Dominion Nuclear Connecticut, Inc.  
Millstone Power Station  
Rope Ferry Road  
Waterford, CT 06385

Millstone Power Station, Unit No. 2  
Technical Specifications Change Request (TSCR) 2-10-01  
Fuel Pool Requirements

Technical Specification Change Request (TSCR) 2-10-01  
Fuel Pool Requirements  
Discussion of Proposed Changes and Safety Summary

FIGURE 3.9-1A MINIMUM REQUIRED FUEL ASSEMBLY EXPOSURE AS A FUNCTION OF INITIAL ENRICHMENT TO PERMIT STORAGE IN REGION C

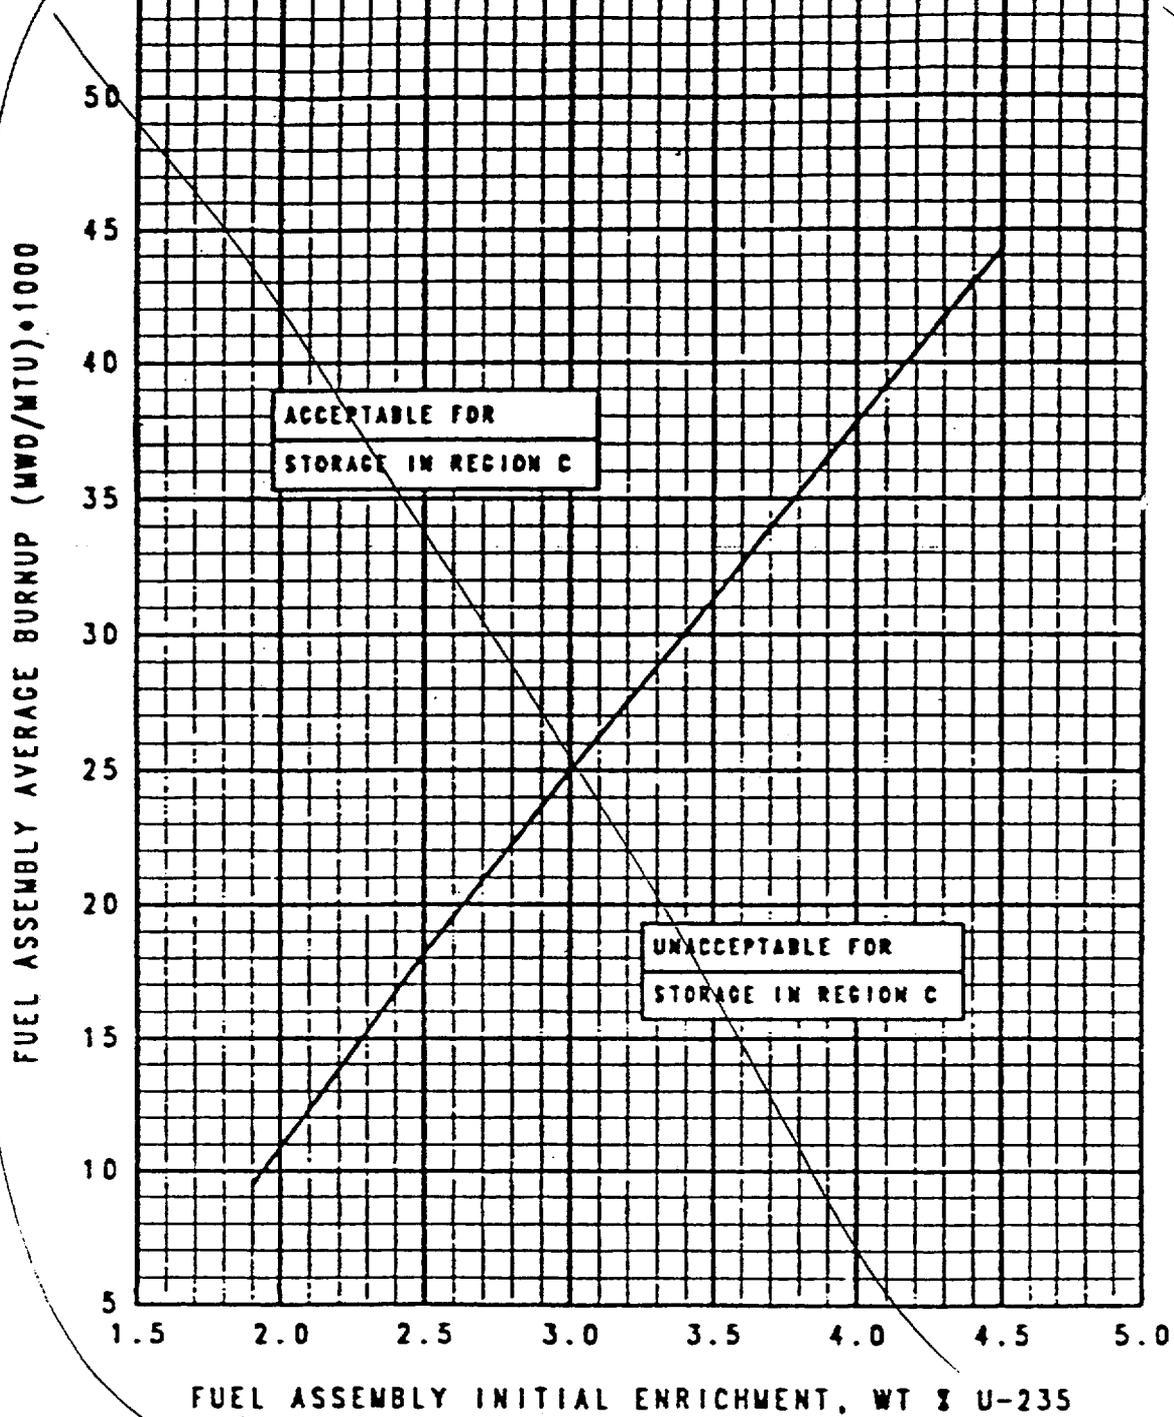
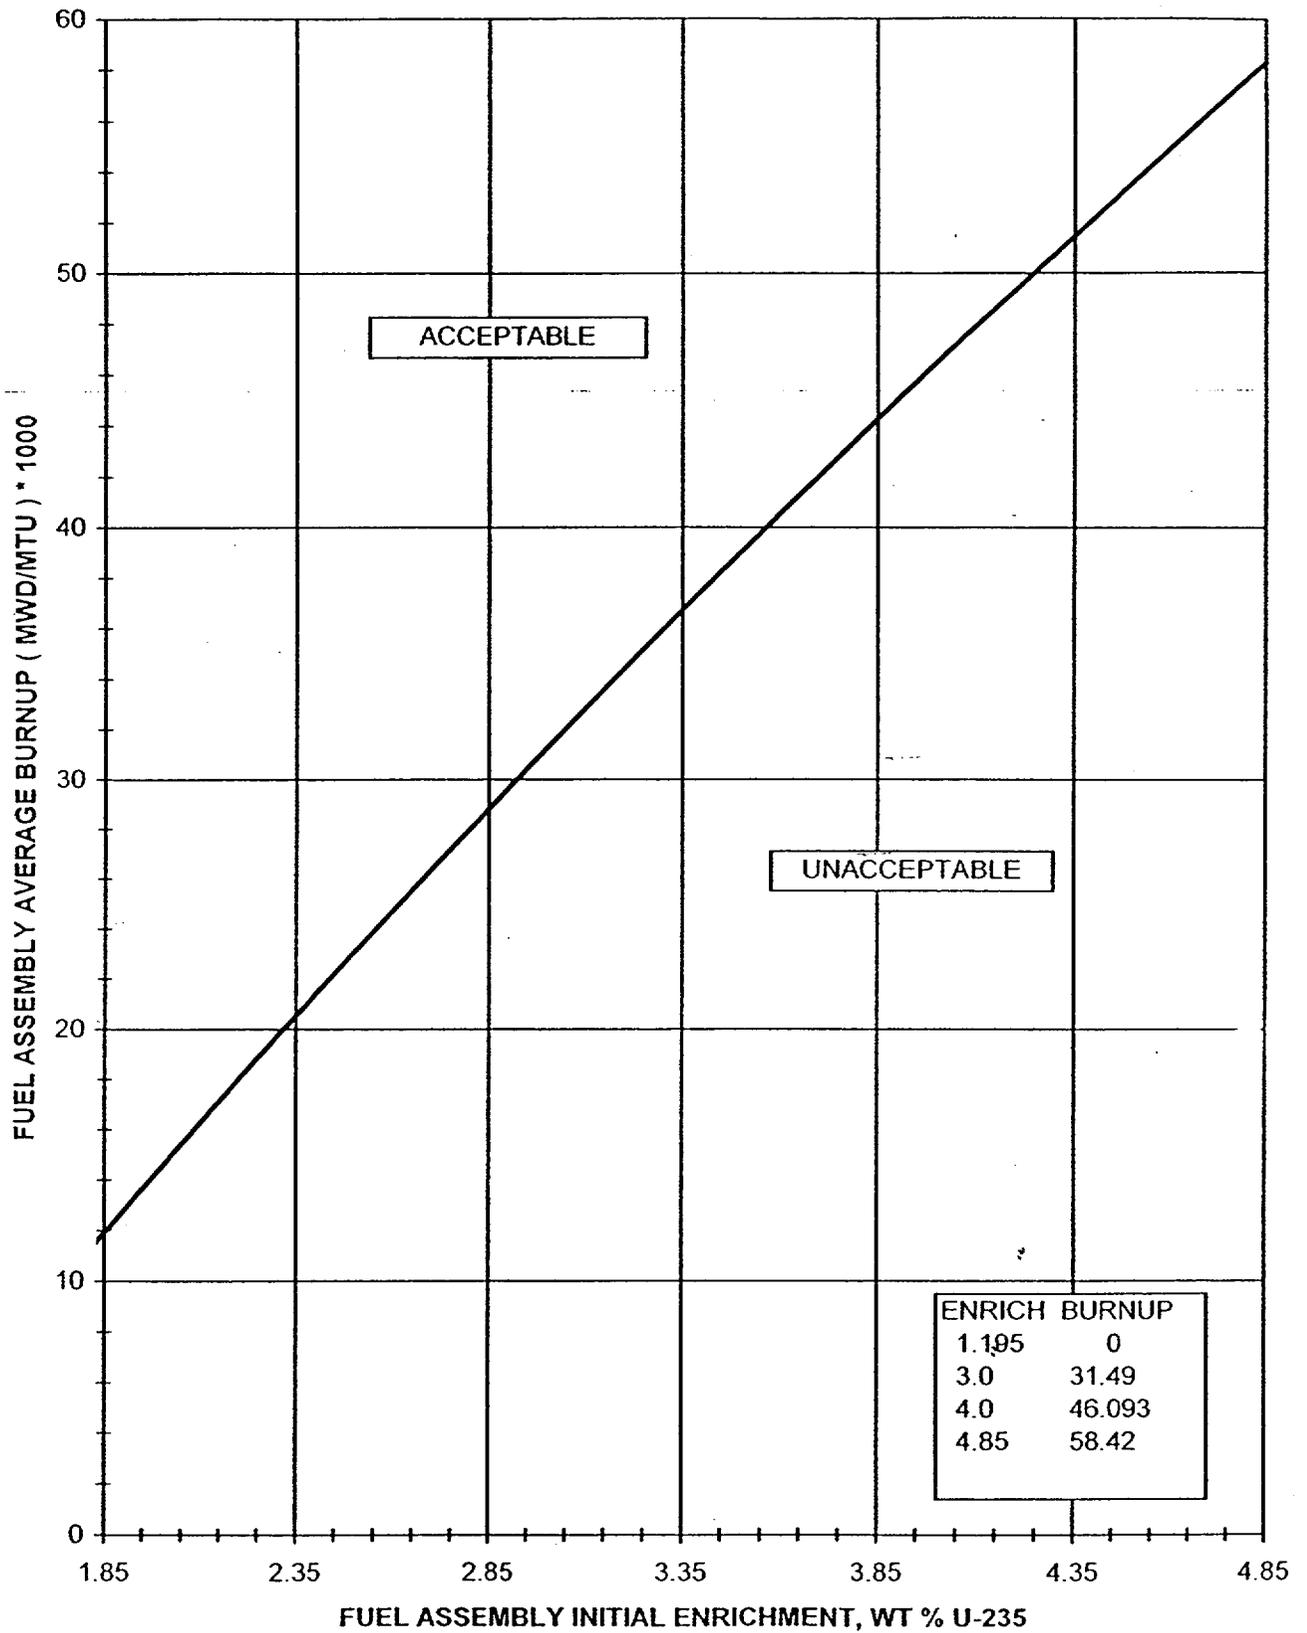
This TS figure shows the minimum required fuel assembly exposure as a function of initial enrichment to permit storage of fuel assemblies in Region C. This TS figure is revised to reflect the revised criticality analysis.

The values shown in this Figure are taken from the criticality analysis that is attached. The required burnups shown in the proposed Figure 3.9-1A are slightly smaller than the current limits due to soluble boron credit.

Replaced with ~~Figure 3.9-1A~~ new Figure 3.9-1A

SPENT FUEL POOL ARRANGEMENT  
FIGURE 3.9-2

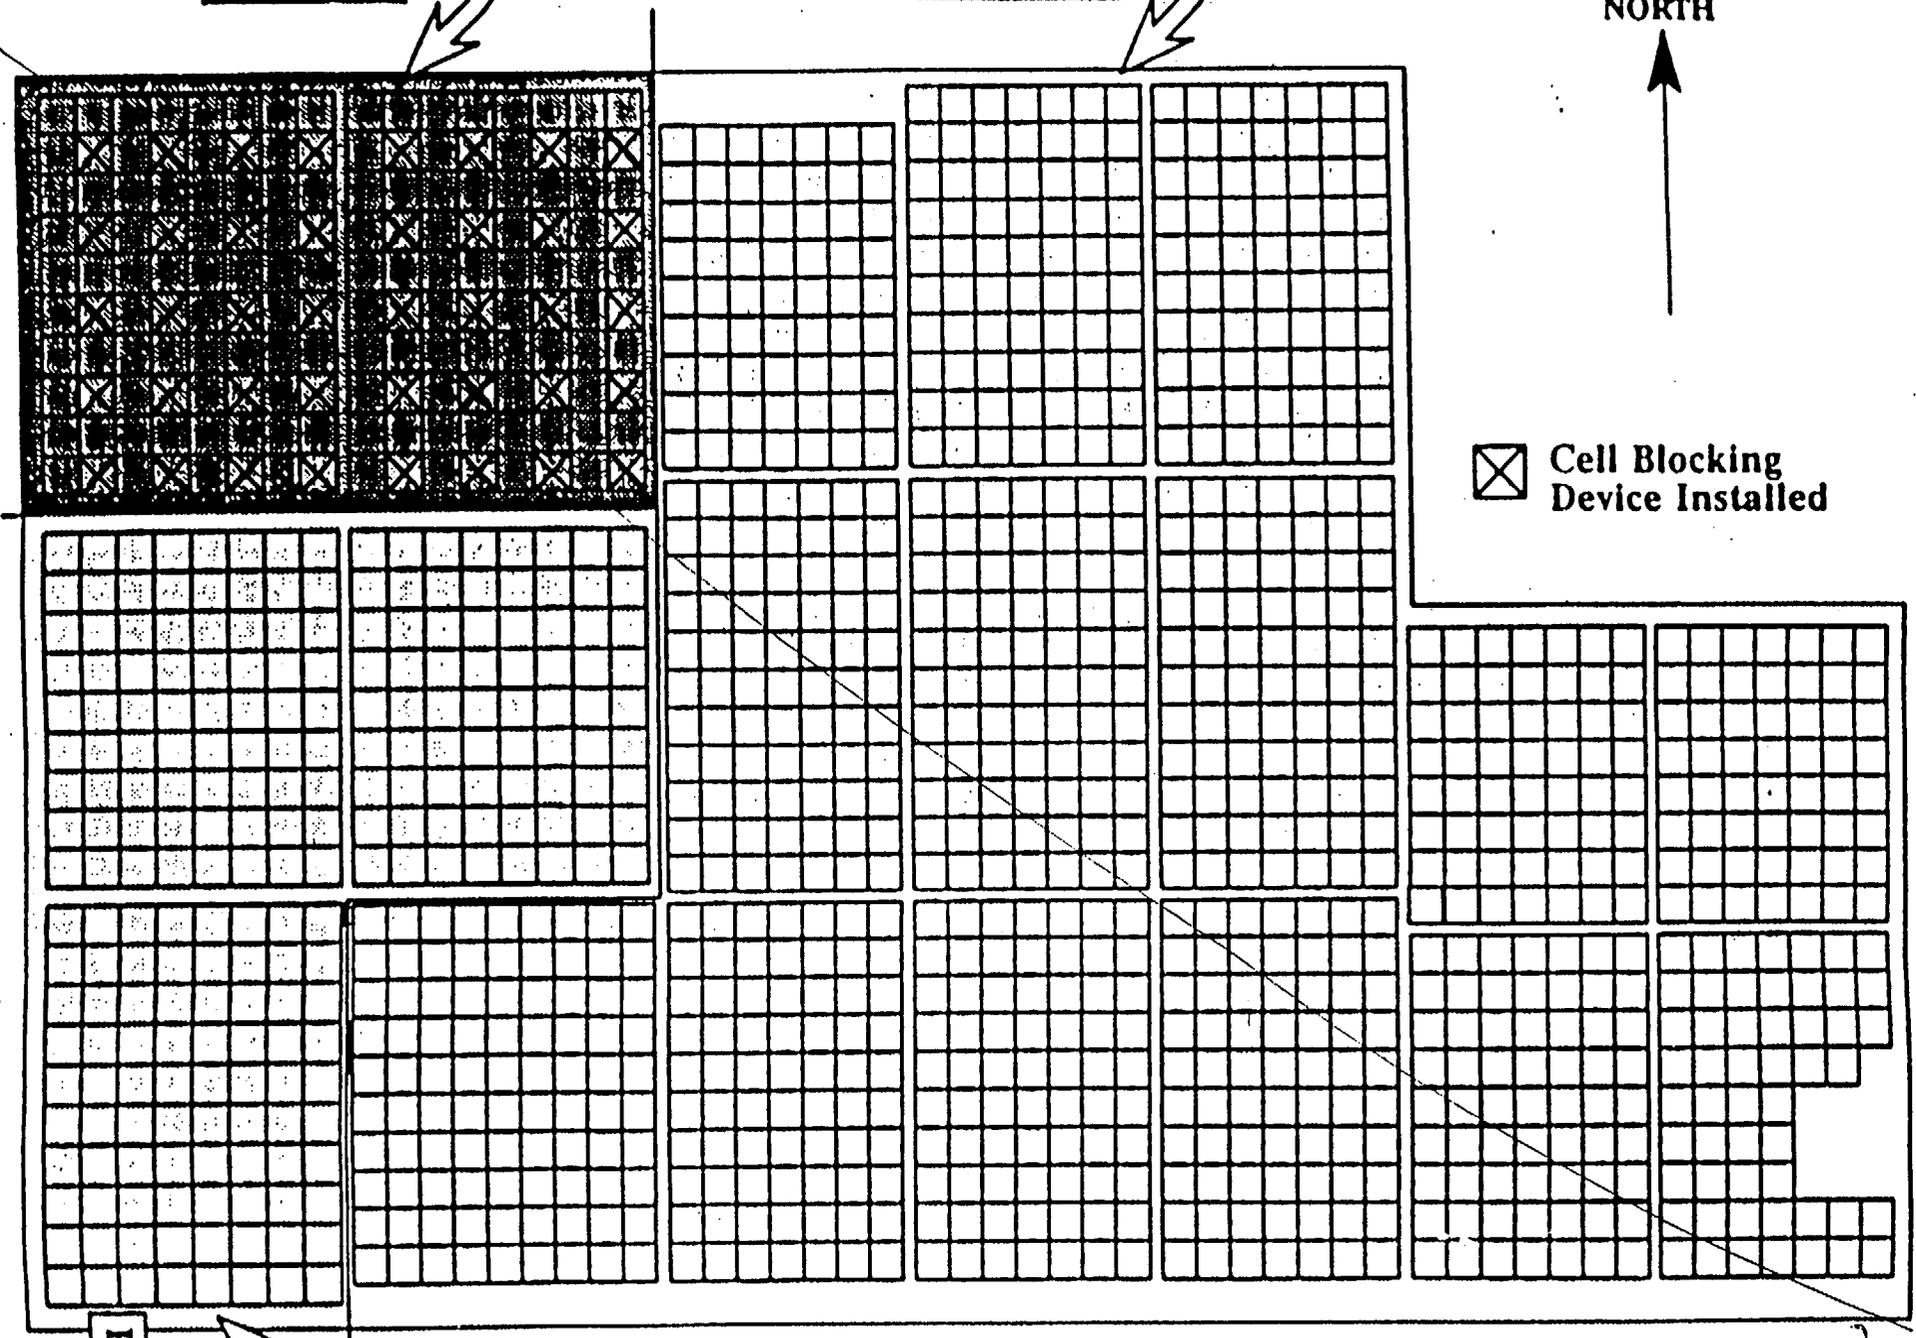
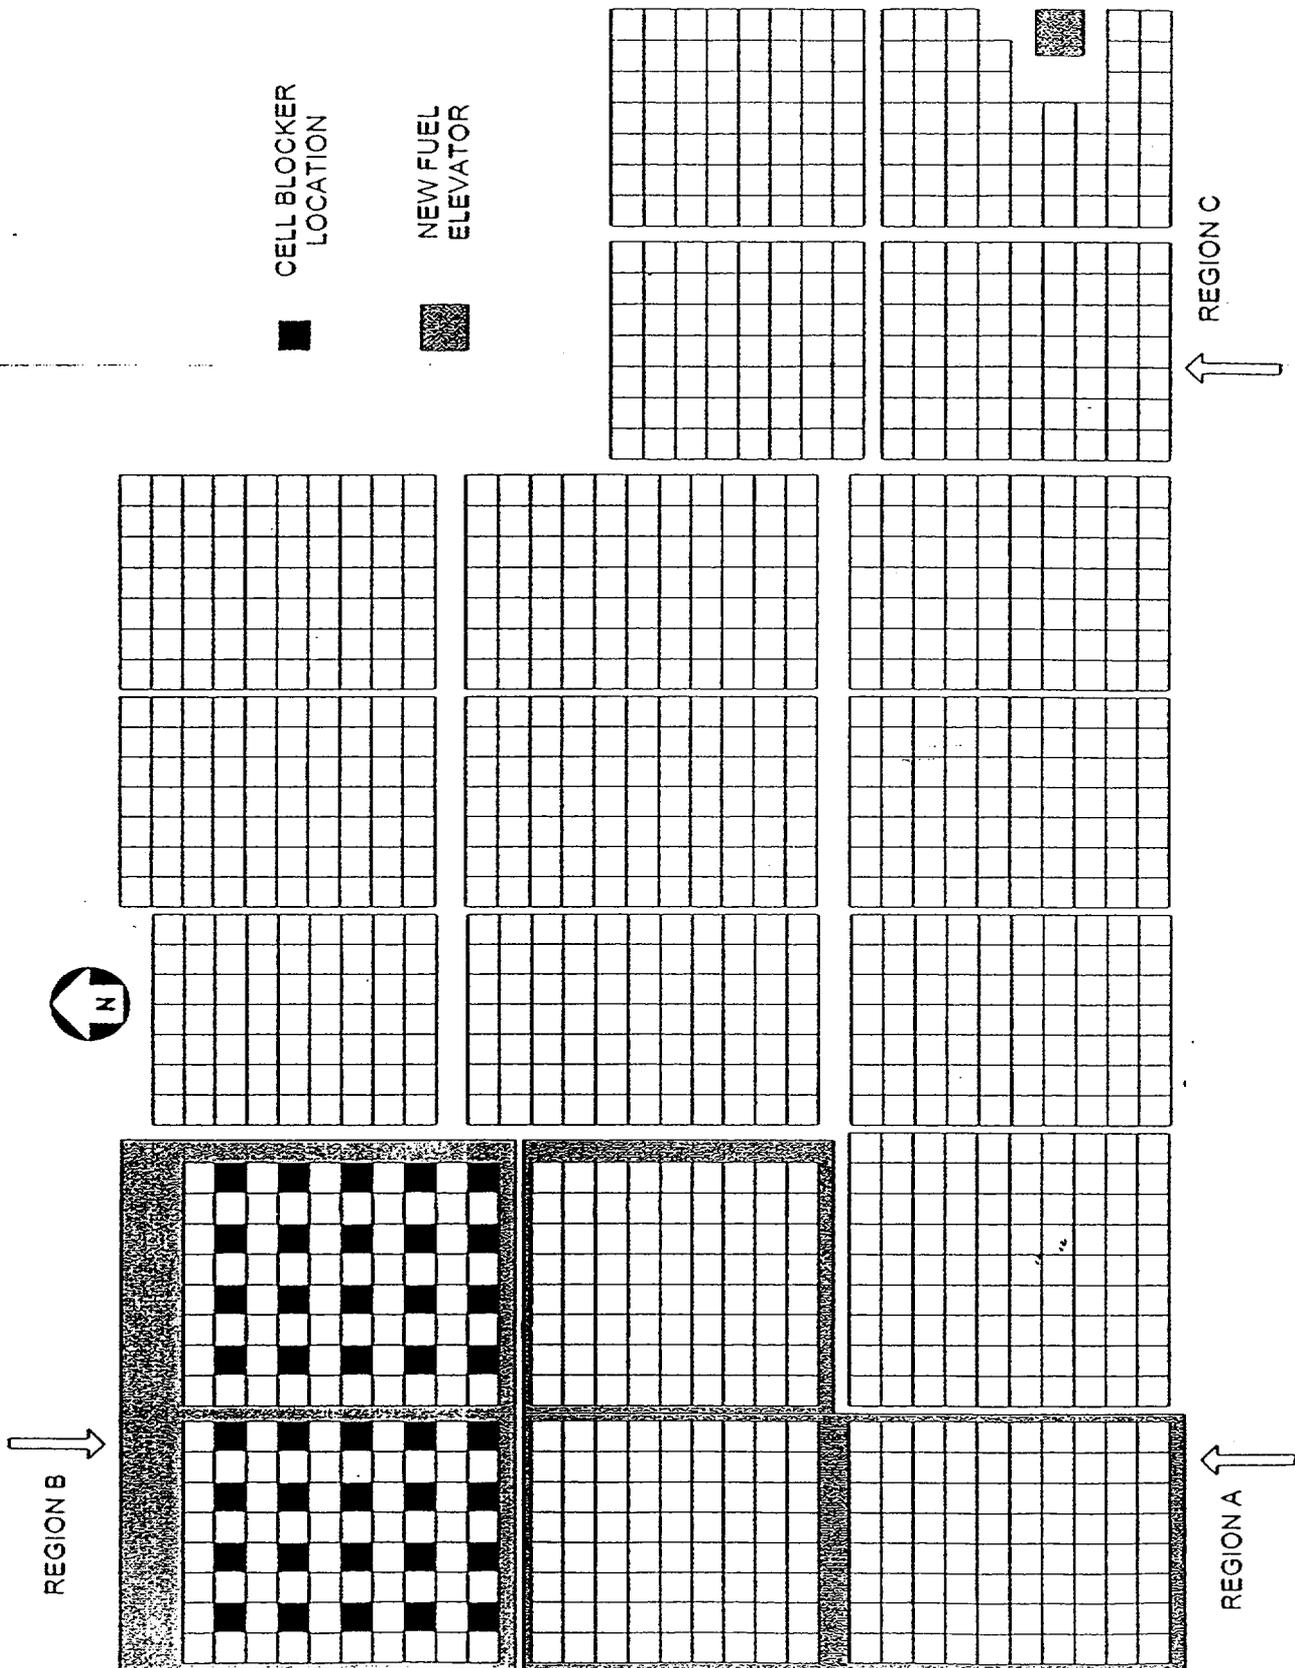
This proposed TS figure is revised only to provide a clearer Figure to show the spent fuel pool arrangement. There are no changes to the Figure.

Replace with used Figure 3.9-2
